Memorandum

Date: April 4, 2013

Re: Station at Riverside Redevelopment
Response To Questions/Comments
City of Newton/Riverside Office
Properties

Revised Grove Street Plans

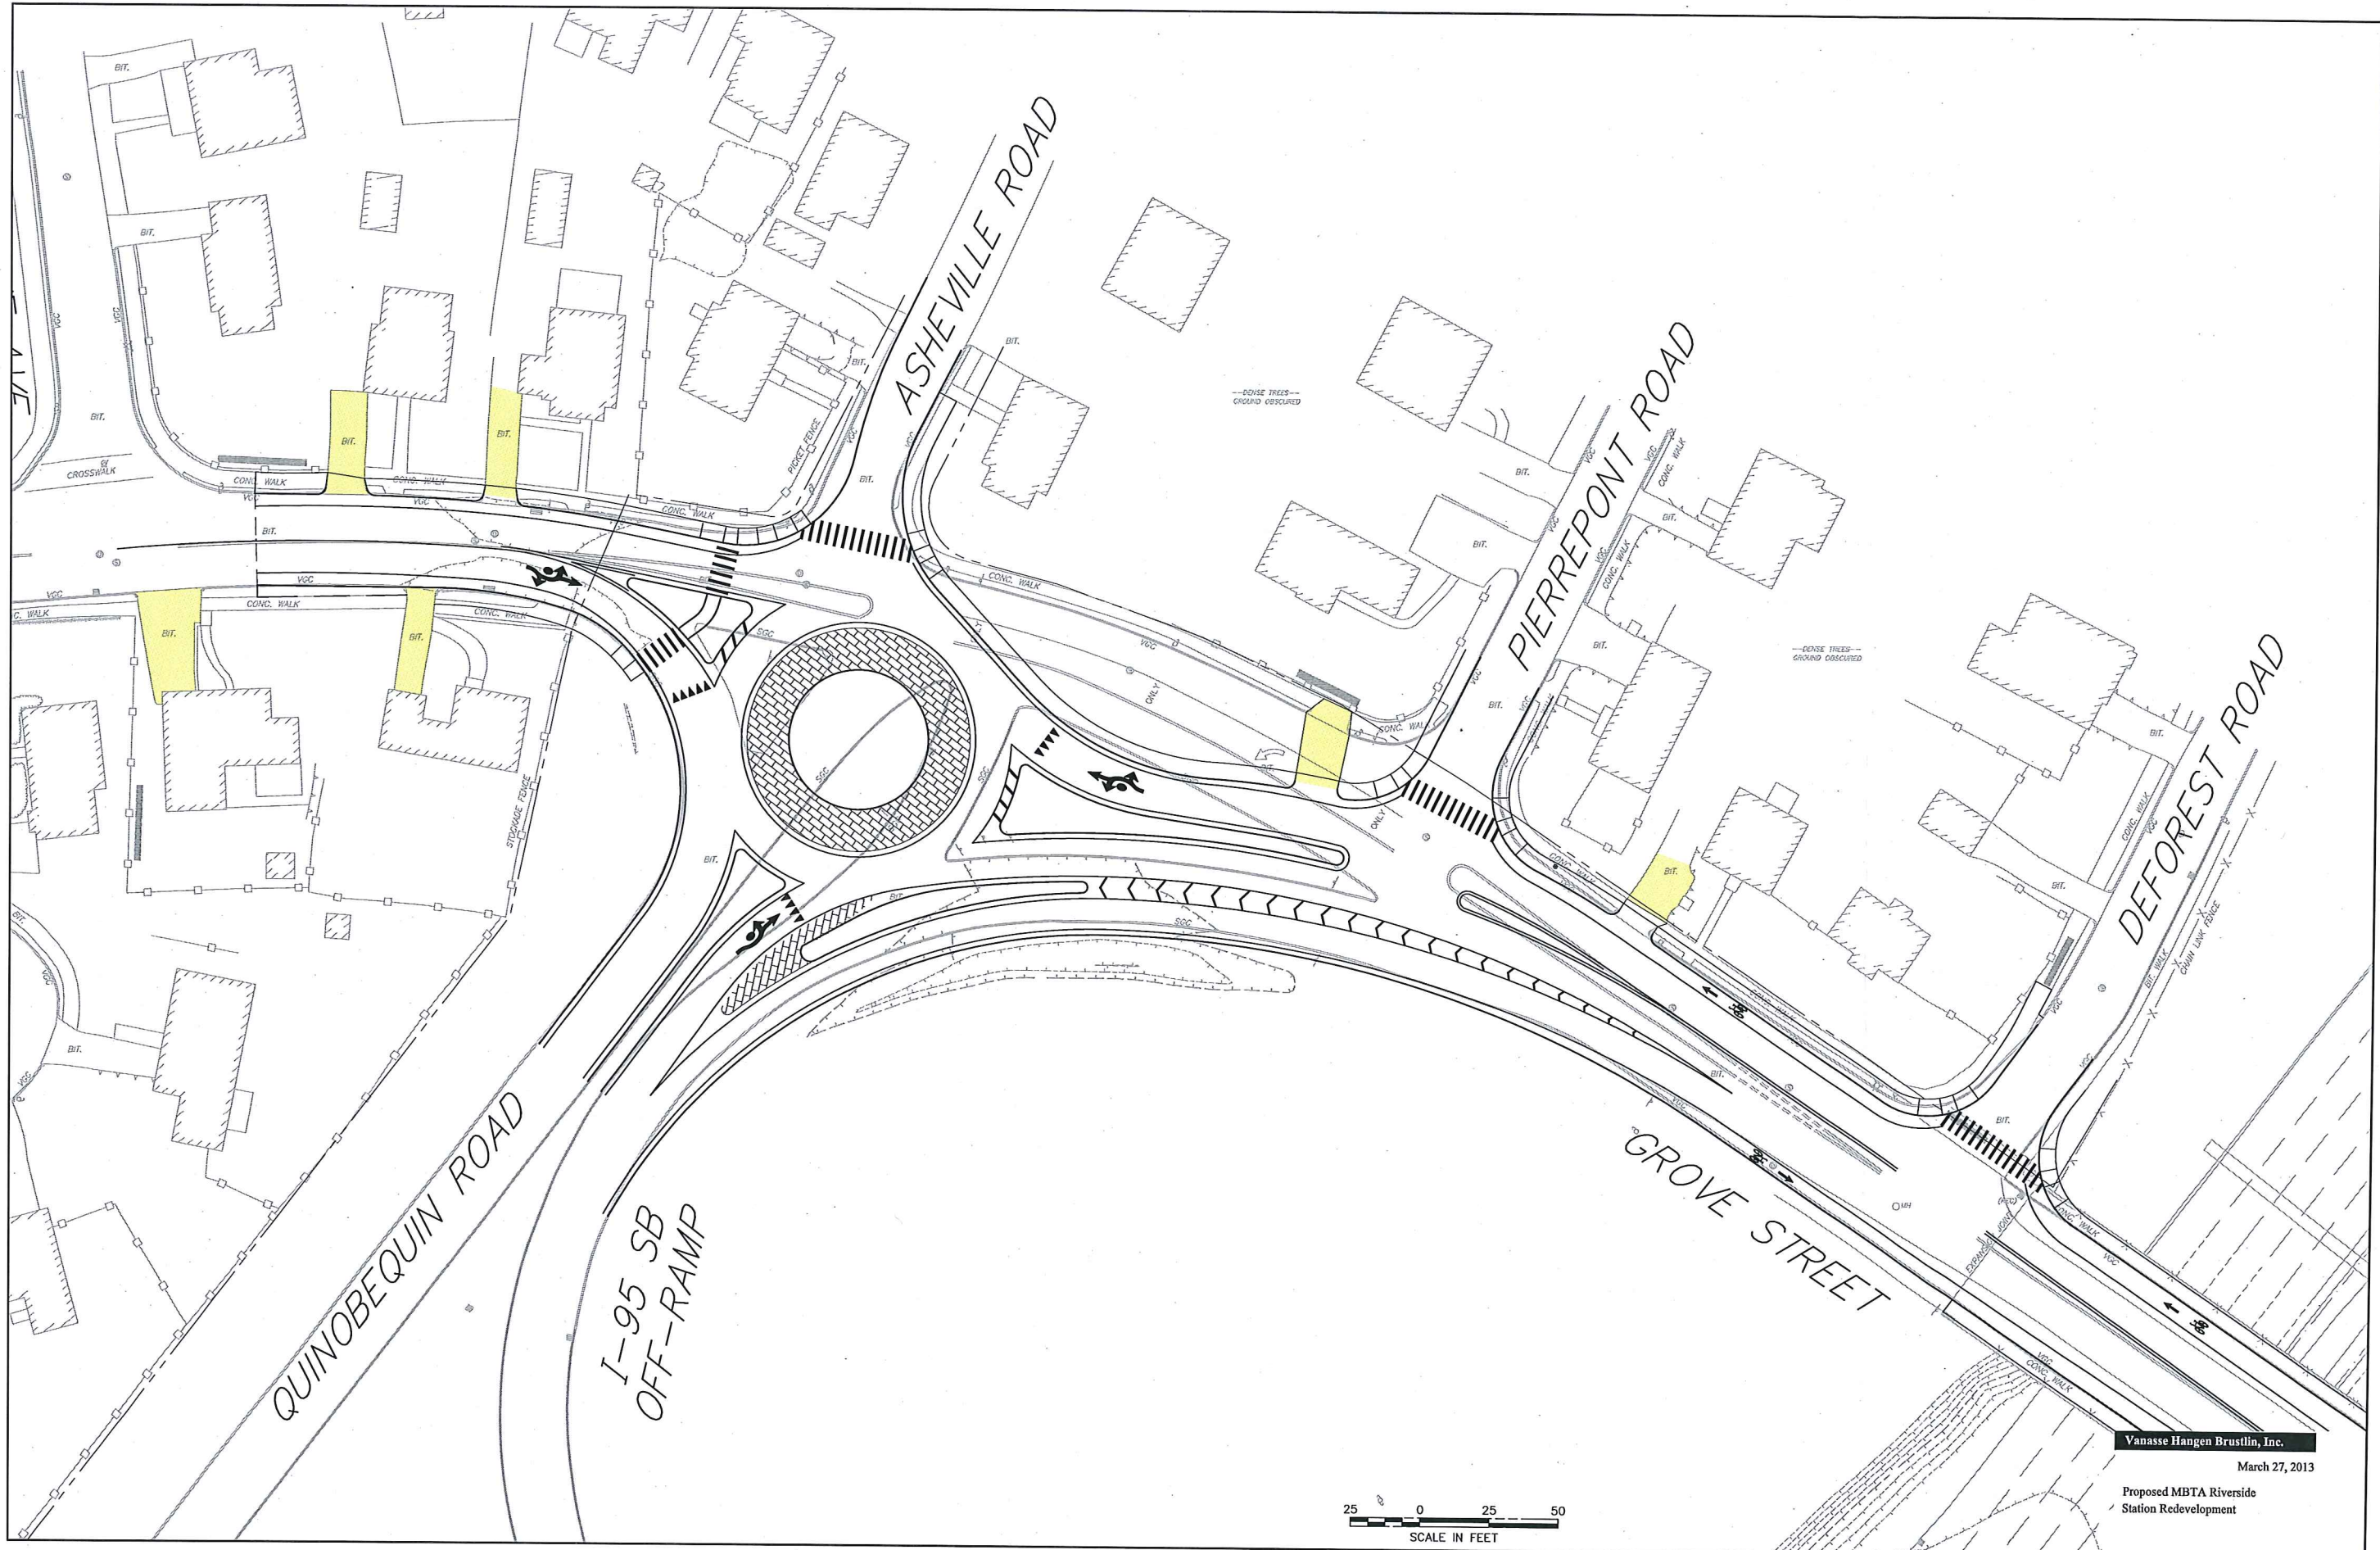
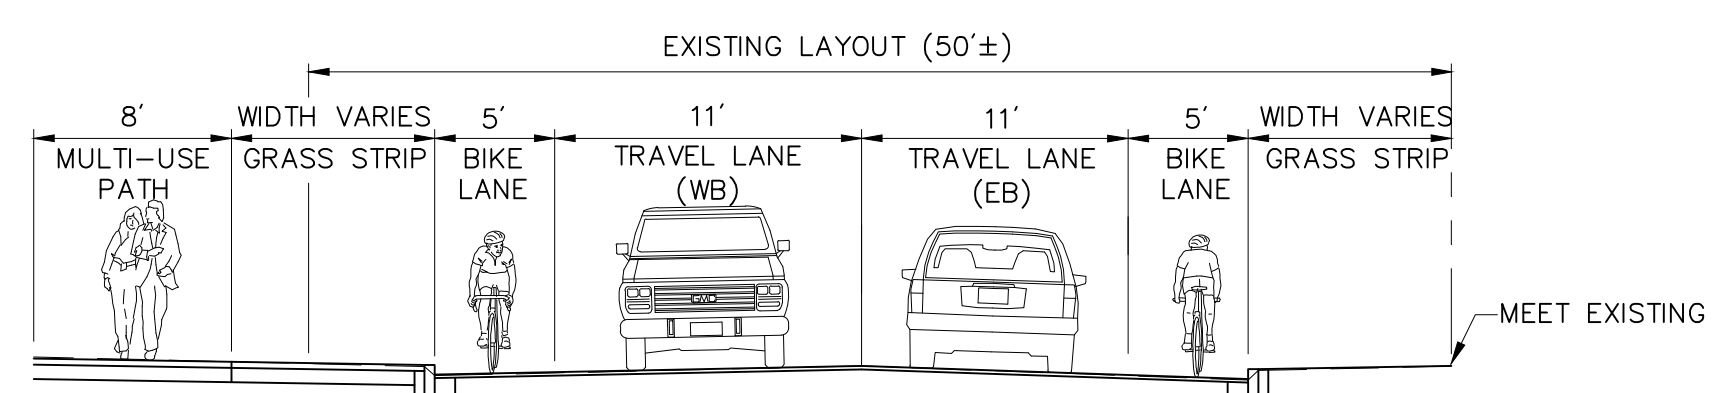
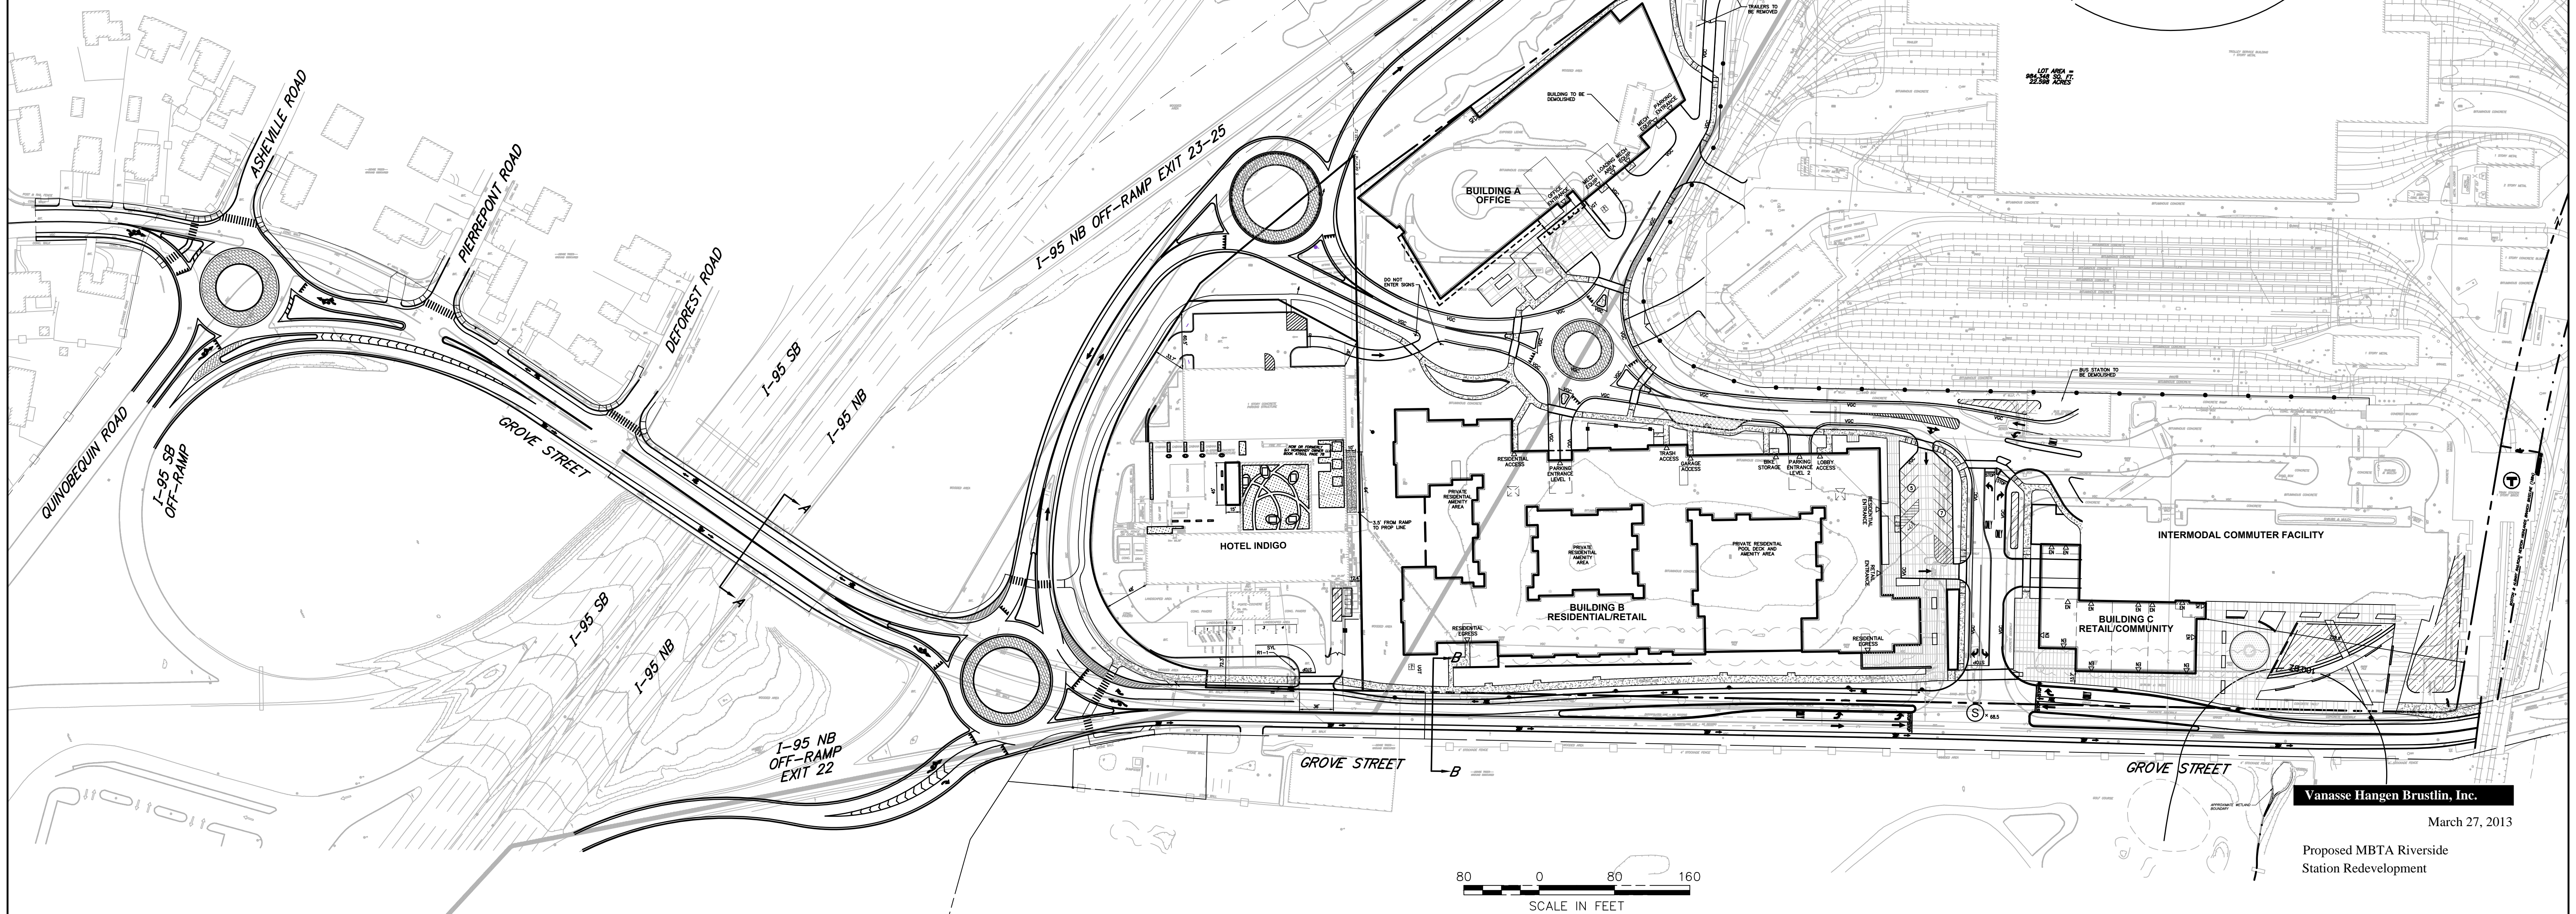
Comment: *Proposed layout of bike lanes along Grove Street, including transitions at roundabouts and trestles*

Comment: *Revised layout for Grove Street to show better deflection at roundabouts, bike lanes on Grove Street, and a cycle track on the bridge. While I know this might normally be considered later on, for the purposes of our current discussion, I think it would be helpful to show how this can work, even if it has to change later for logistical reasons. I think we should start with what is most desired by the community and seek support to make it happen rather than take off the table now.*

Comment: *Can we put "cycle tracks" on the bridge*

Response: VHB has prepared an updated plan of the Grove Street improvements which provides continuous five foot bike lanes on each side of Grove Street within the project limits. The updated plan is included in the Attachments at both 11x 17 and full scale versions (see “Revised Grove Street Plans section of the attachments).

- Bike lanes and cycle track on bridge
 - A formal bike 5 foot lane has been added to both sides of Grove Street within the limits of the project.
 - The eastbound lane drop tapers required east of the SB ramp roundabout terminate on the bridge utilizing the majority of the southerly shoulder. The alignment has been shifted to balance the eastbound and westbound shoulders so that a minimum of 5 feet of shoulder is available were required to provide a continuous 5 foot bike lane in both directions within the project limits.
 - See below for cycle track discussion.

Response: Cycle tracks, by definition, are separate from travel lanes and pedestrian by a physical barrier, such as on-street parking or curb, or are grade separated. Cycle tracks using a barrier separation can be at-grade, or either above or below the level of the travel lanes and cross-streets. The introduction of a "cycle track" on the bridge over Route 128 is something that can be considered and discussed with MassDOT moving forward provided it is designed in a way that does not add any dead load to the bridge structure or become a hazard for approaching vehicles. Also, it should be designed in way that would allow easy maintenance particularly from the perspective of snow removal. Ultimately MassDOT has jurisdiction over the bridge and they will decide what is most appropriate but for the purpose of being responsive to the comment, VHB has prepared an updated plan that includes formal bike lanes along Grove Street for the section where improvements are proposed (see "Revised Grove Street Plans section of the attachments)
